Stressed receiver sensitivity setup and calibration (comments R1-304 R2-196, R2-203)

Piers Dawe and Jakob Toft
NVIDIA

Figure 121–8—Stressed receiver conformance test block diagram

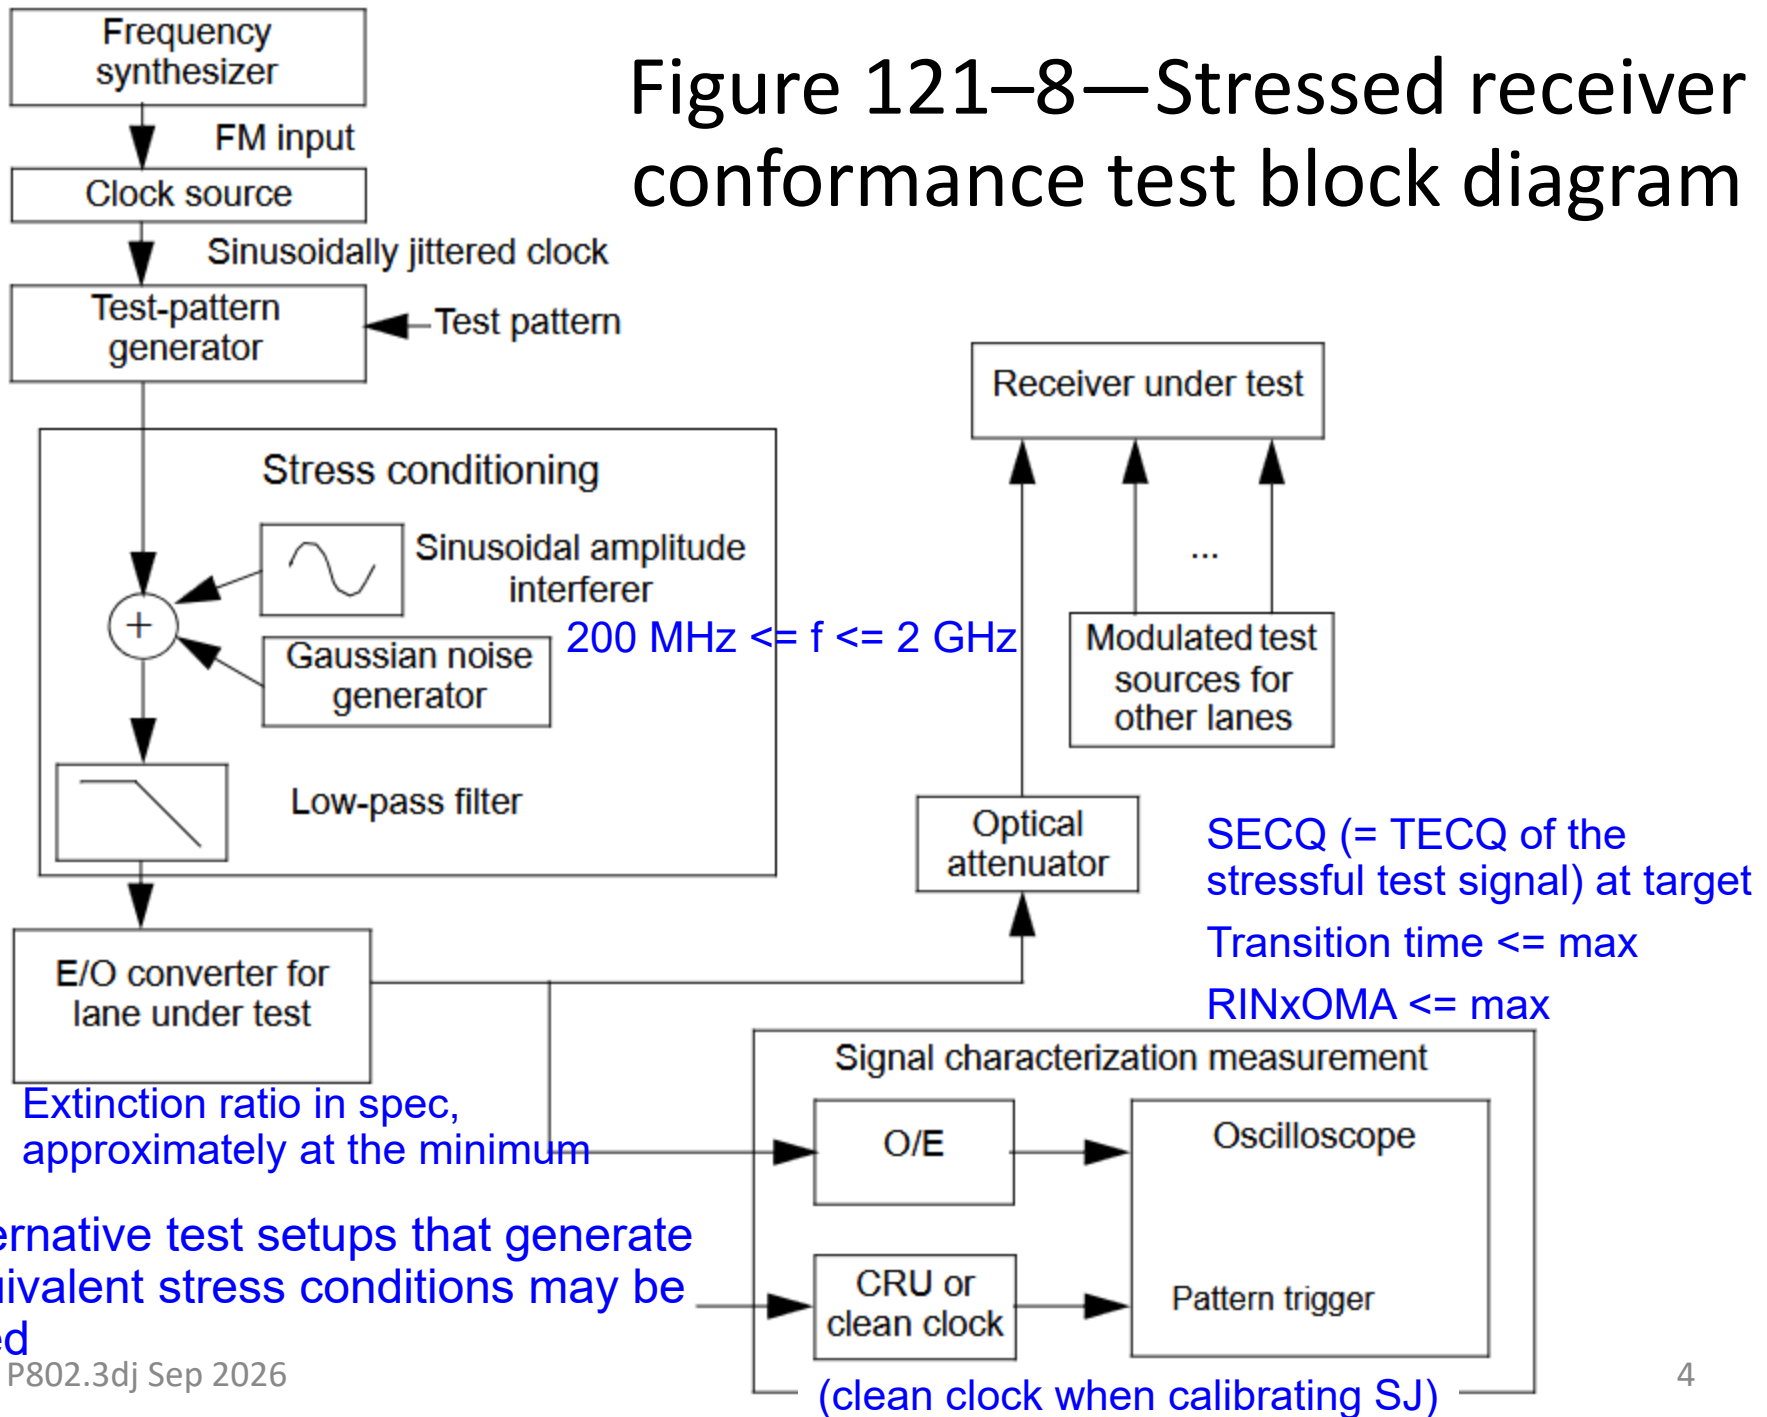
- The **sinusoidal amplitude interferer** may be set at any frequency **between [200] MHz and 2 GHz**, although care should be taken to avoid harmonic relationships between the sinusoidal interferer, the sinusoidal jitter, the signaling rate, and the pattern repetition rate. The Gaussian noise generator, the amplitude of the sinusoidal interferer, and the low-pass filter are adjusted so that the specified SECQ is met.
- For improved visibility for calibration, all elements in the signal path ... should have wide and smooth frequency response, and linear phase response, throughout the spectrum of interest. Baseline wander and overshoot and undershoot should be negligible.

The test implementer chooses the mix of filtering, Gaussian noise and SI amplitude. Also the SI frequency

Some choices can give very unrealistic signals

Often the penalty from SI is very large

- With reference to Figure 121–8: change from sinusoidal interferer to PRBS13Q, summed with the others before the low-pass filter as today
- With a QPRBS interferer, there are many frequencies. They are aliased too, but the noise enhancement of the aliased spectrum and the real spectrum is similar so that's OK

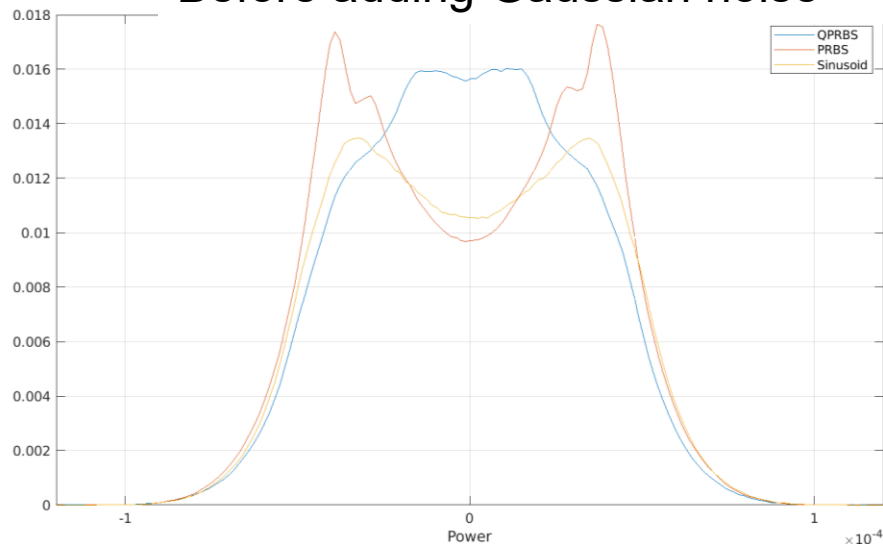
- PSU noise should not dominate
 - If we are very concerned about it, that would be a separate tolerance spec with a MUCH lower interferer frequency
- The single SI frequency, which the receiver must tolerate, is unrealistic

- The strong single-tone nature of the SI could confuse some repetitive process in a DSP

Simulated stressful signal for SRS testing: vertical pdfs of 4 levels combined

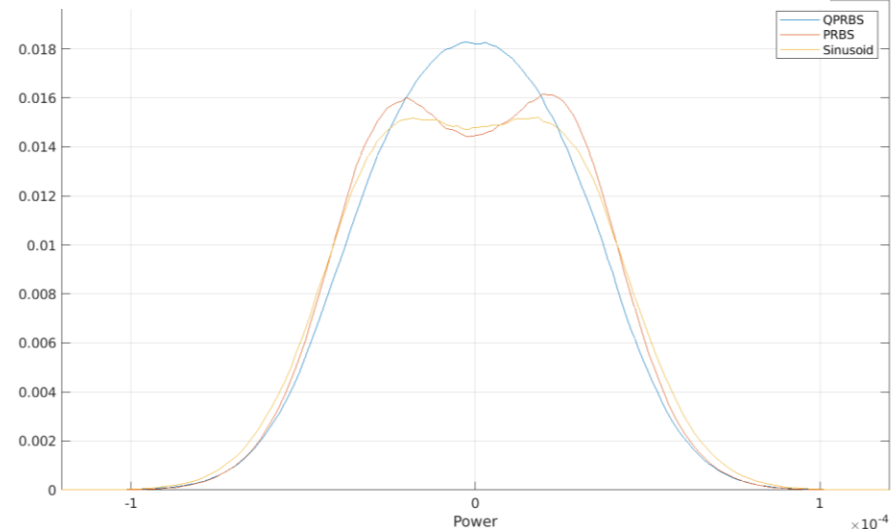
Unrealistic bimodal distribution

- A sinusoidal interferer is close to "dual-Dirac"
- PAM2 PRBS has the same problem
- Because the interferer is quite strong, the way people build stressed signals today, the resulting PAM4 histograms have two peaks for each level
- This is unrealistic

- To avoid the 2-moded histogram problem, use a PAM4 QPRBS rather than a PAM2 PRBS
 - PRBS13Q is a well-known pattern with more than enough lines for this purpose but short enough to be generated by an arbitrary waveform generator

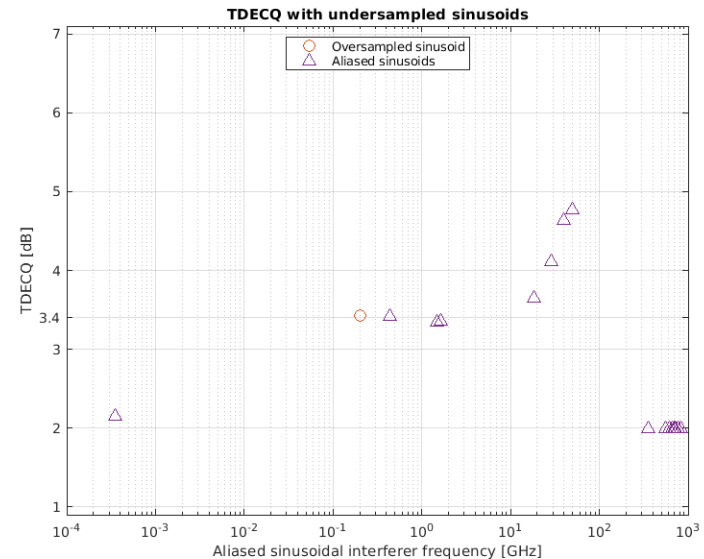
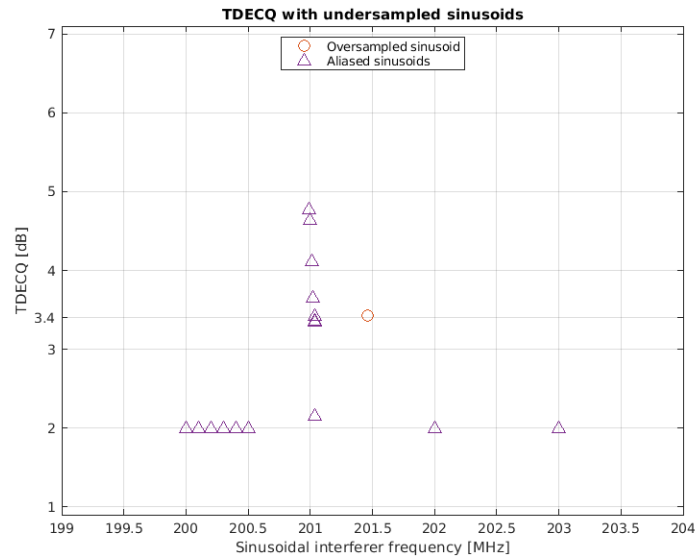
- Examples of aliased SI spectra
 - if the aliasing does not distribute the spectrum
- A difference of 100 kHz in sinusoidal frequency can move the aliased frequency by 100 GHz

- Simulations with constant SI amplitude, different frequencies as on previous slide. Assuming the aliasing does not distribute the spectrum. Left: SECQ vs. actual frequency; right: vs. aliased frequency
 - Simulations with the same SI amplitude at different frequencies give very different (apparent) SECQ: ± 3.4 dB
- If the aliasing does distribute the spectrum
 - the error is smaller than the extreme, and consistent
- In calibration, the SI amplitude would be adjusted to bring the apparent SECQ to the target, giving very different real stress
